Peer Review Report
Canadian Malartic Project
New Polishing Pond
Osisko Canadian Malartic Project

November 2008

**Re — Peer Review – Canadian Malartic Project
Polishing Pond**

FIG. 1
 1

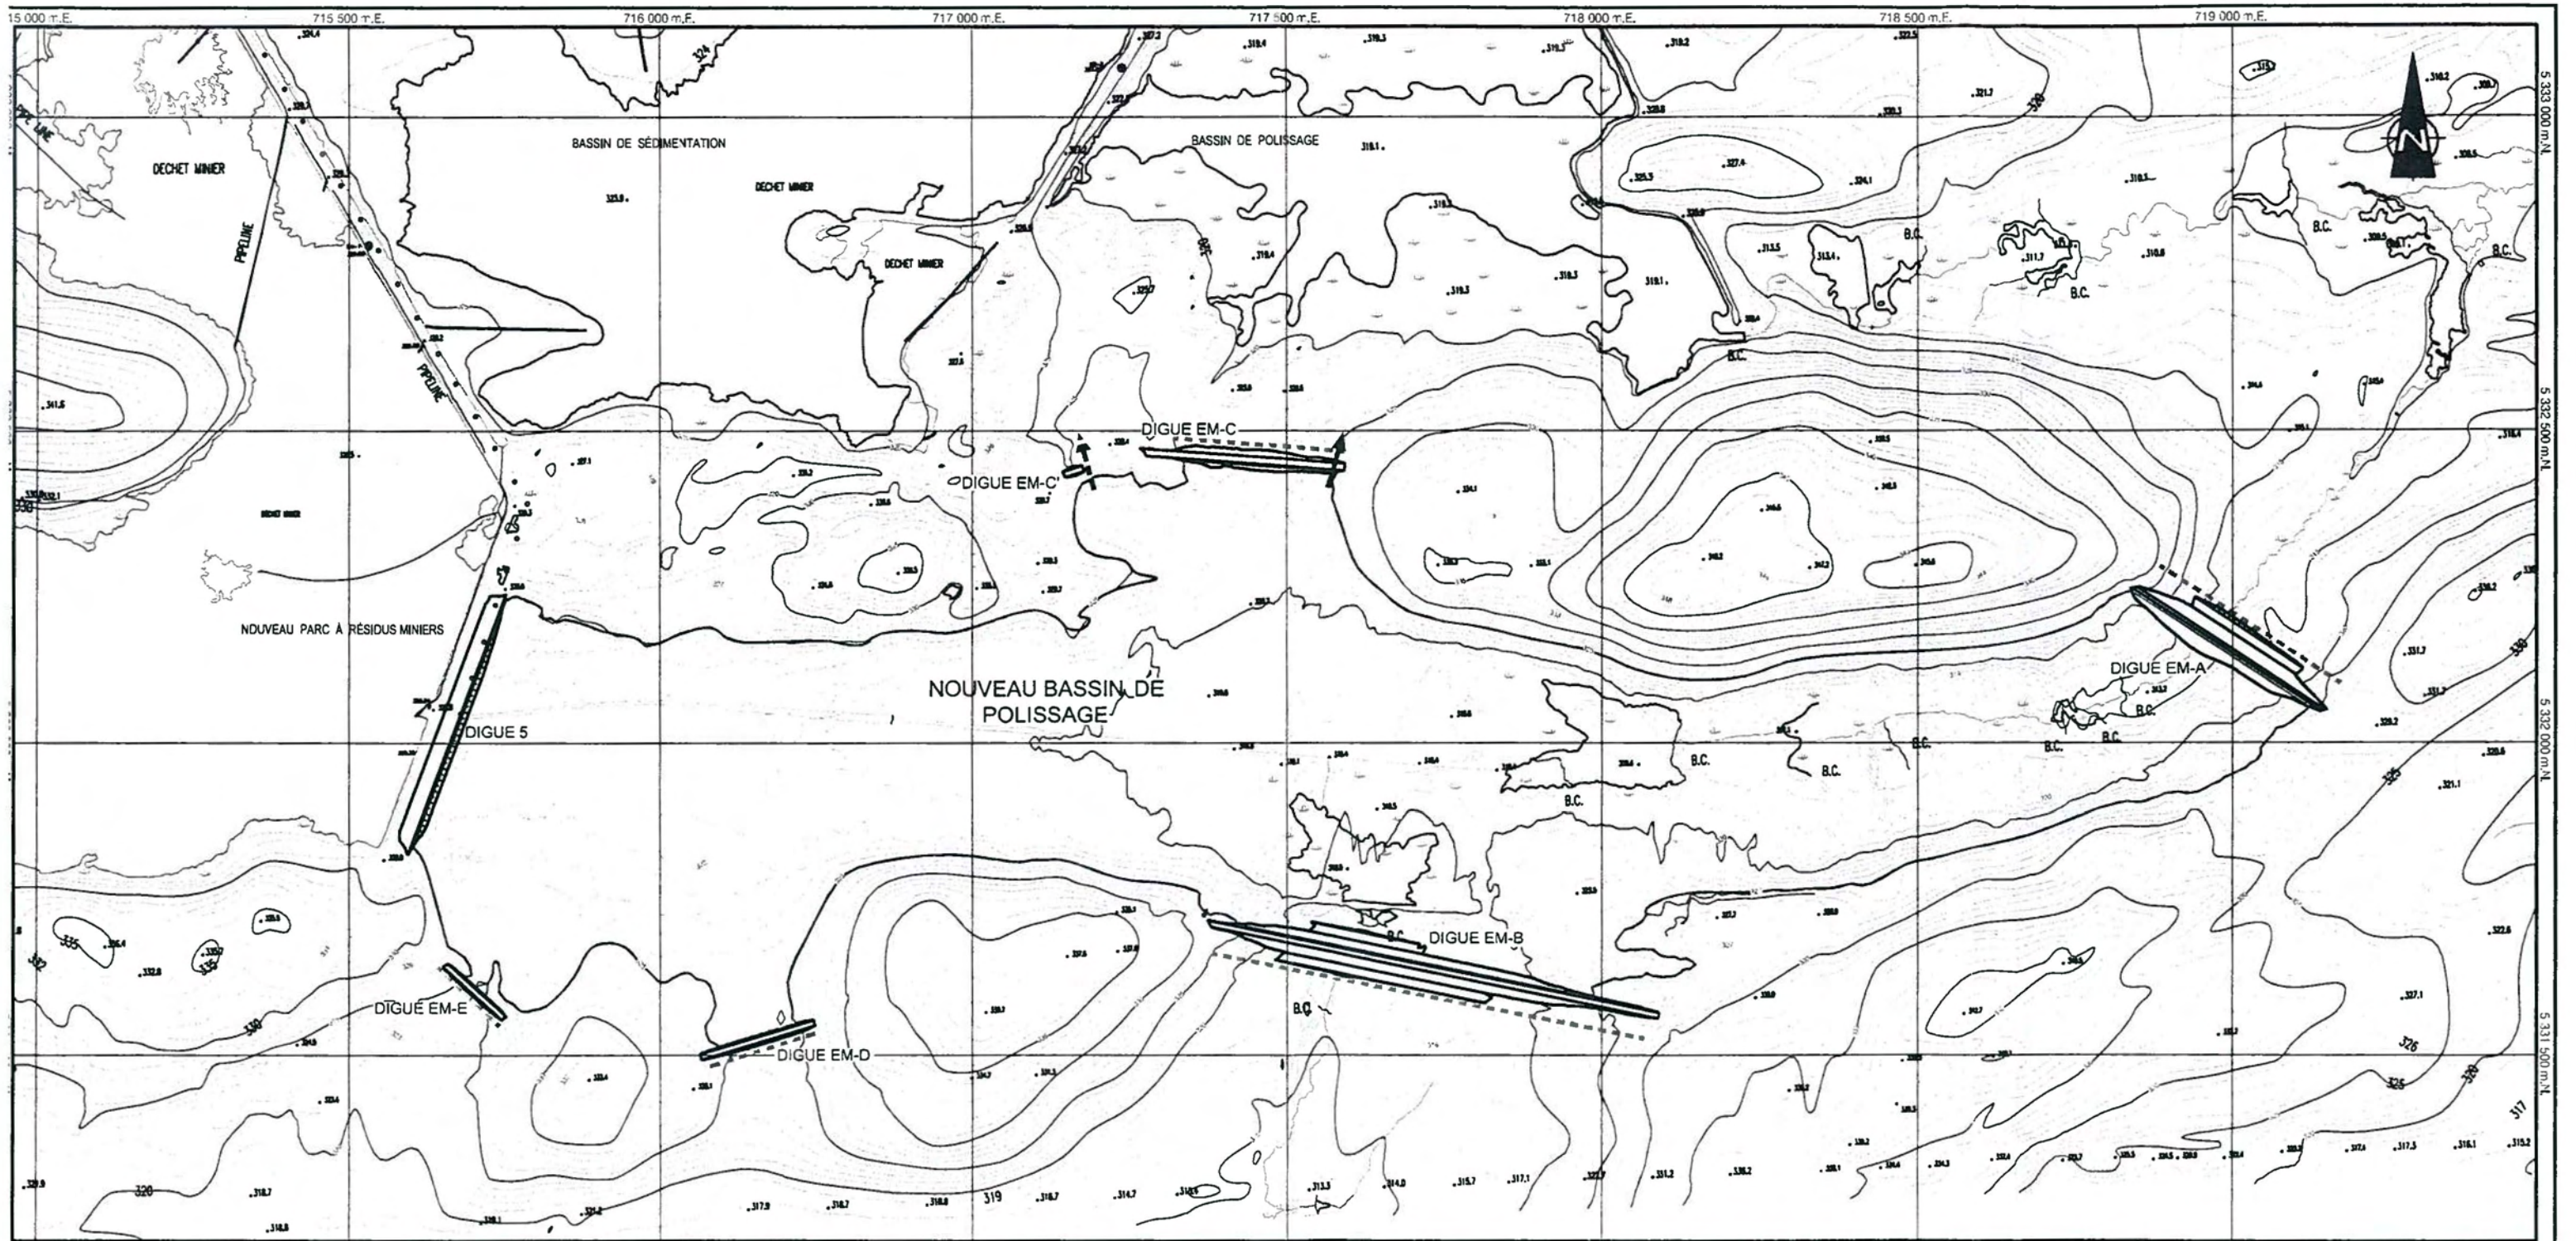
Figure 1 shows a plan of the proposed new polishing pond. It is adjacent to dike 5 of the old tailings pond and the proposed thickened tailings storage pile.

Five dikes are proposed — EM-A, EM-B, EM-C, EM-D and EM-E. The west end of the proposed polishing pond will abut against the dike of the original tailings pond. The site is approximately 2.5km south-east of Malartic. The property is owned by Osisko and is not in the Agricultural Zone.

Section A-A Dike EM-A

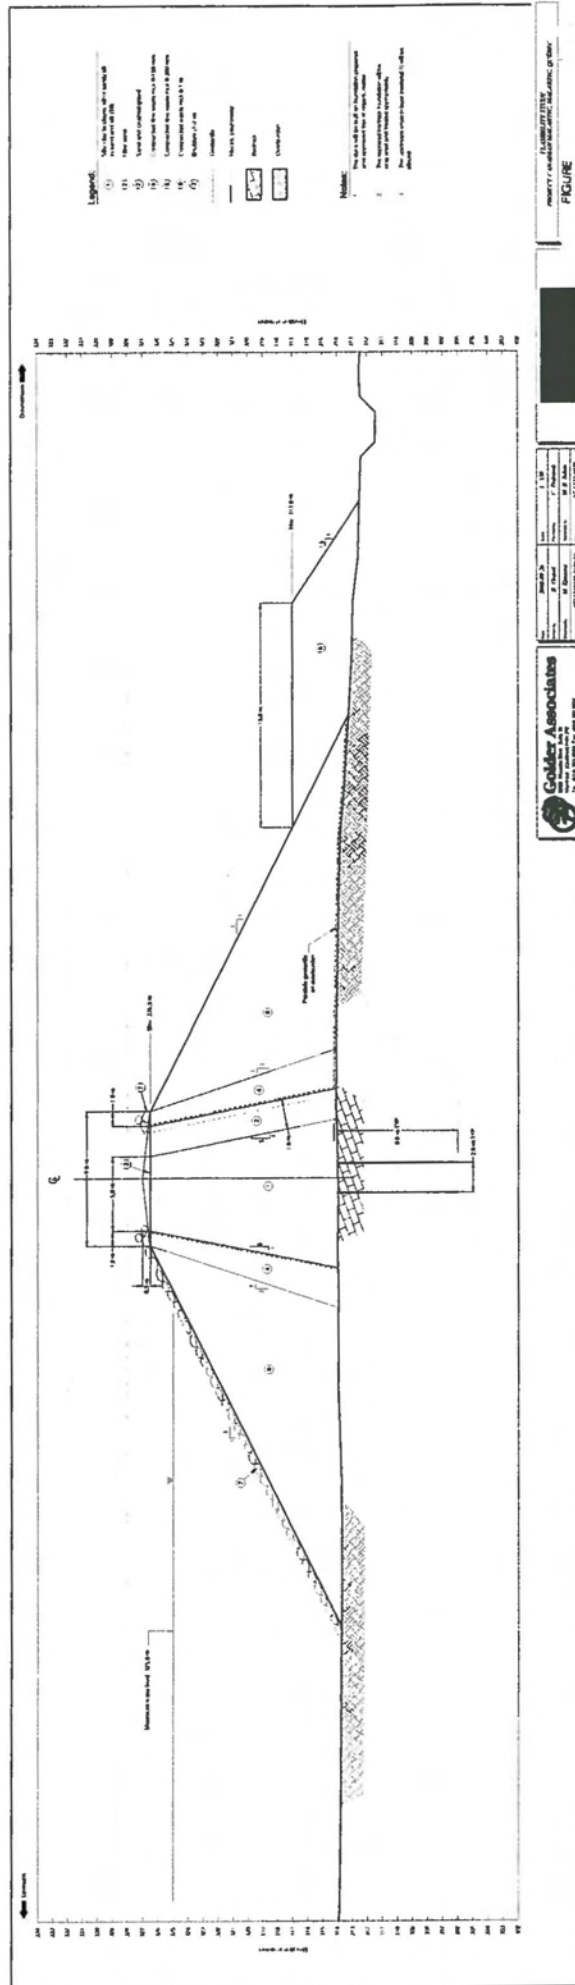
Dike EM-A is the highest structure – 14.5m. The upper rock will require grouting to make the rock less permeable and reduce potential seepage. Figure 2 shows a typical cross-section of Dike EM-A.

Both dikes involve a low permeability silt clay core with a downstream sand filter. Note – this filter layer should have a collector drain pipe along the base and a drain outlet. Geotextile is proposed both upstream and downstream of the core. The outer shell will be compacted tailings.

The downstream slope (2H:1V) should be protected from erosion - either vegetated with erosion-resistant growth or covered with fine-graded waste rock.. The upstream slope (2H:1V) should be covered with boulders placed on a bed of sandy gravel. This cover is to resist wave and ice action.

The core of EM-A is to be founded on bedrock. If the bedrock is fractured it will be grouted with low-pressure grout where the water depth exceeds 4m. Both dikes require stabilizing toe berms.

FIGURE 3

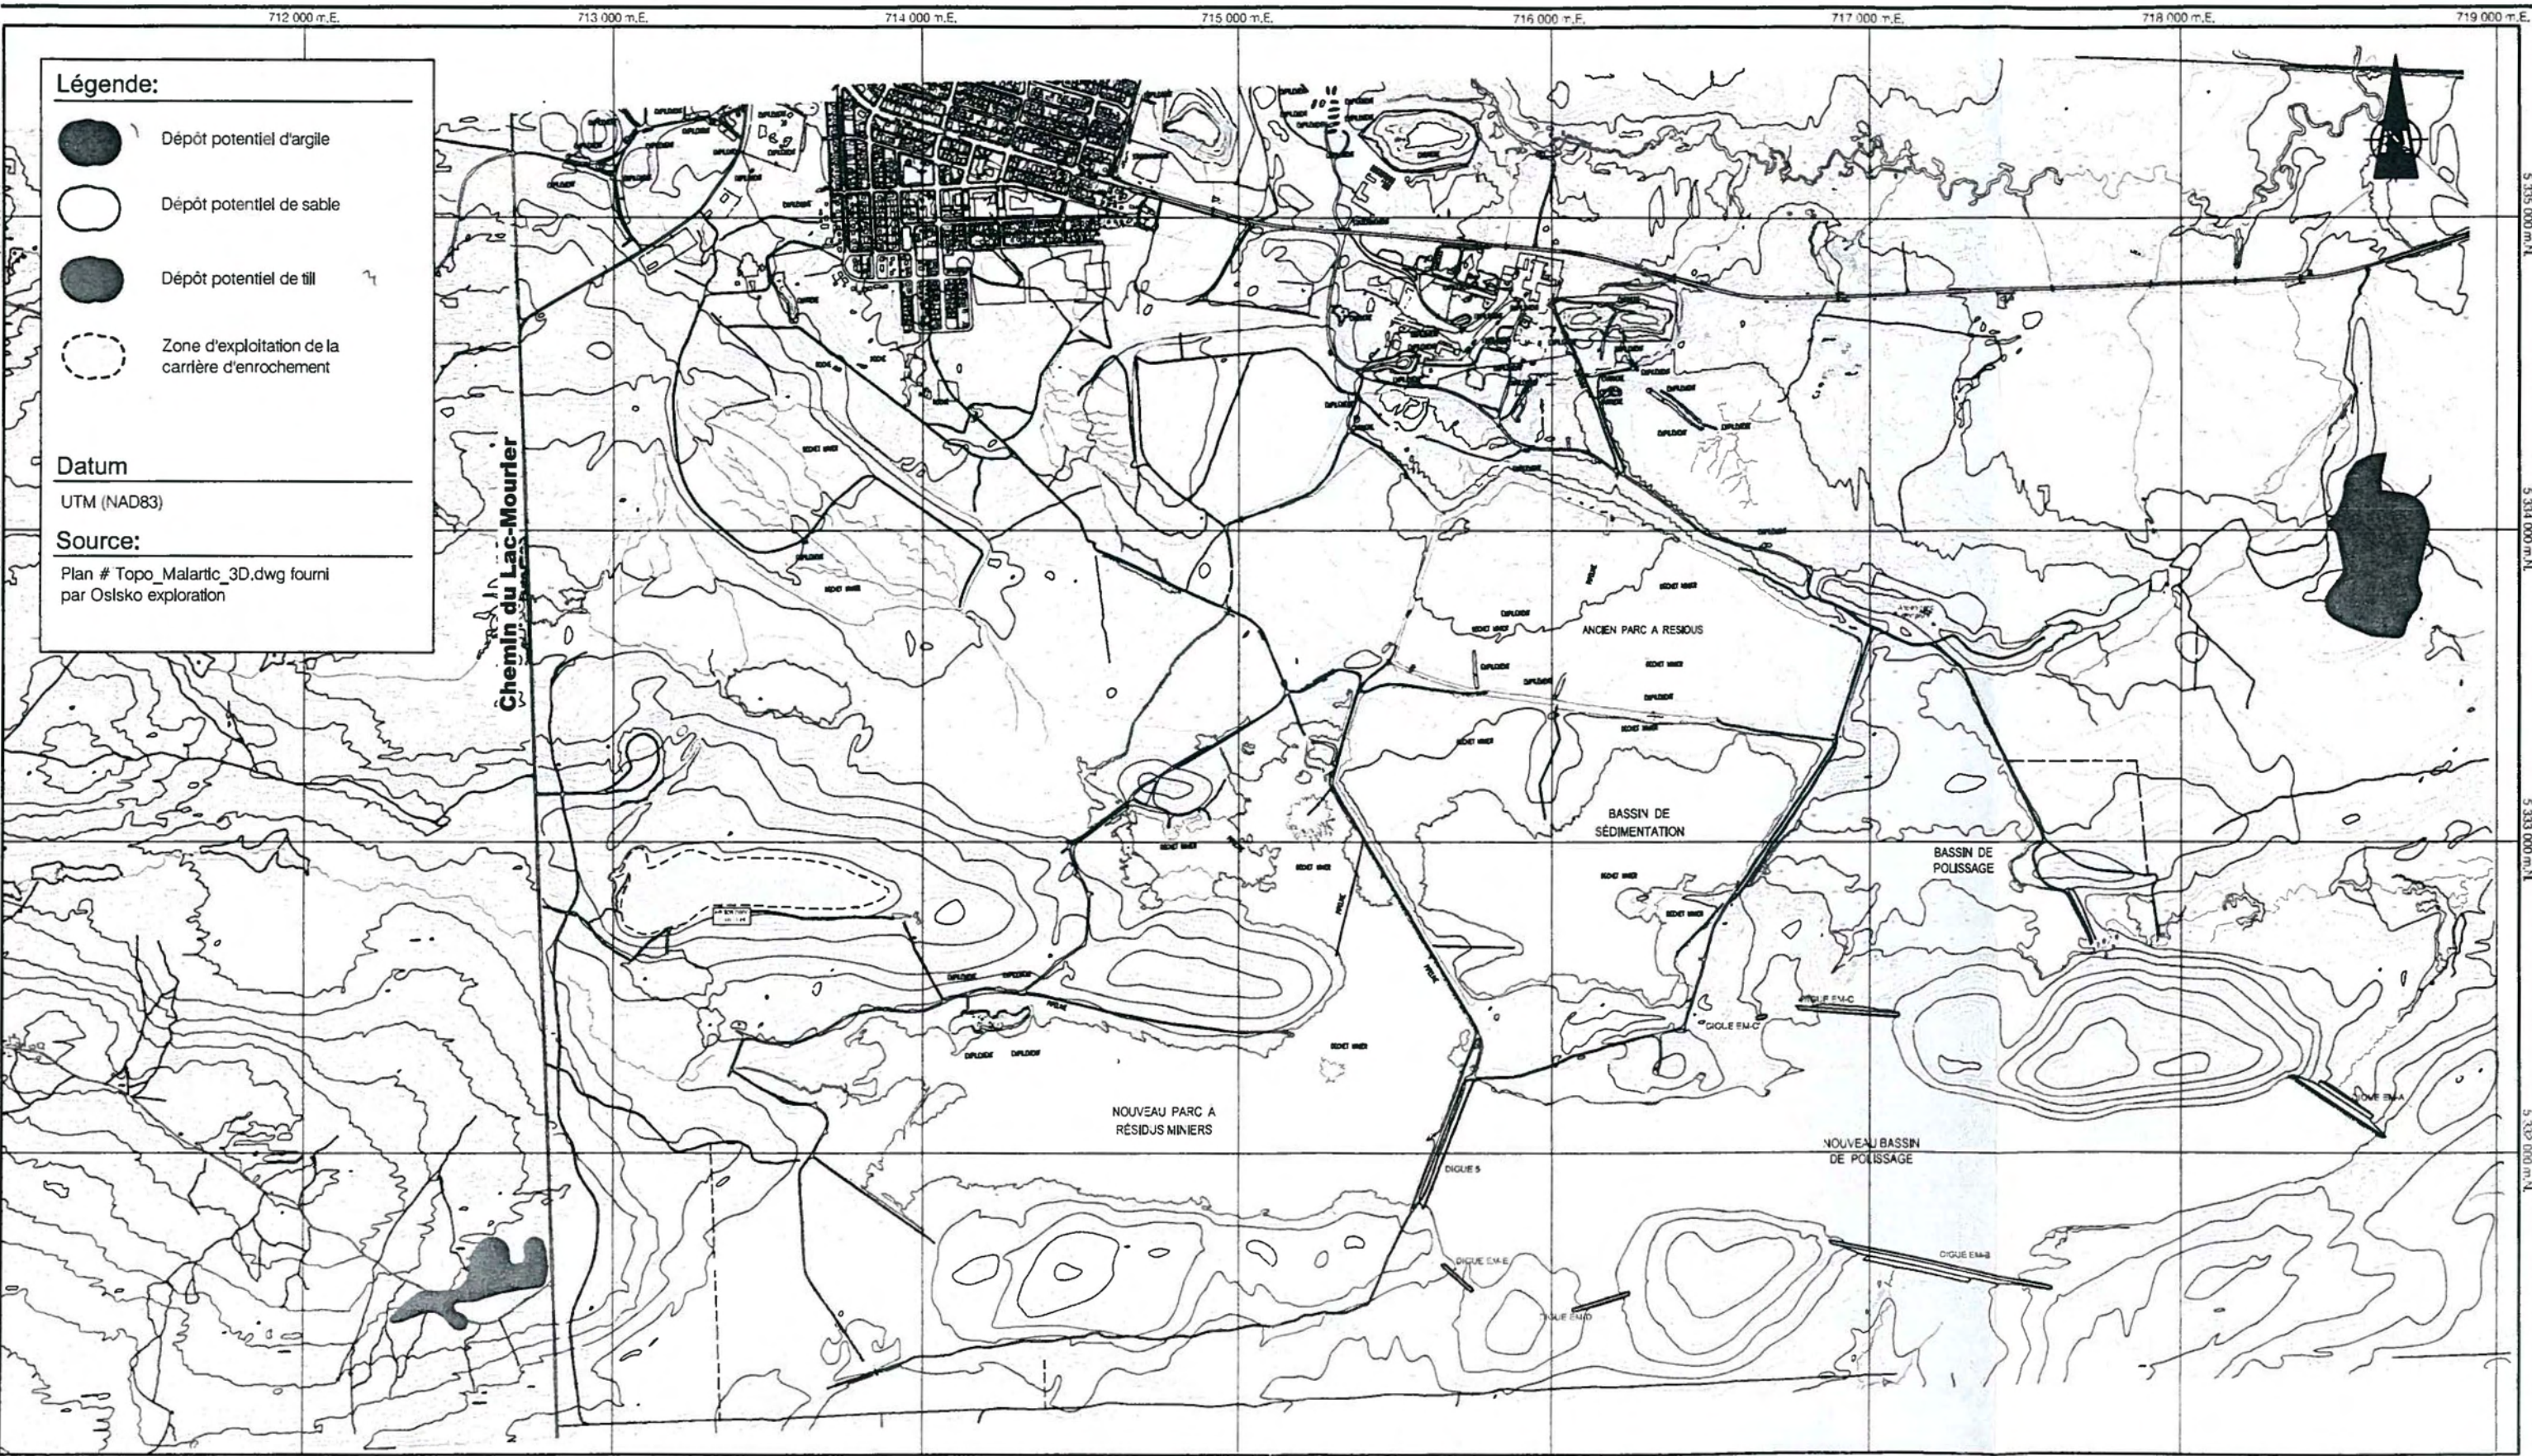
A till borrow pit was located west of Lake Mouvier Road. A silty clay deposit was located north-east of the Est-Malartic mine site. A borrow pit of granular materials was located north of the existing polishing pond. Gravel and rock can be obtained from quarrying at the future plant site and from waste rock from the mine. The location of borrow pits is shown in Figure 3.
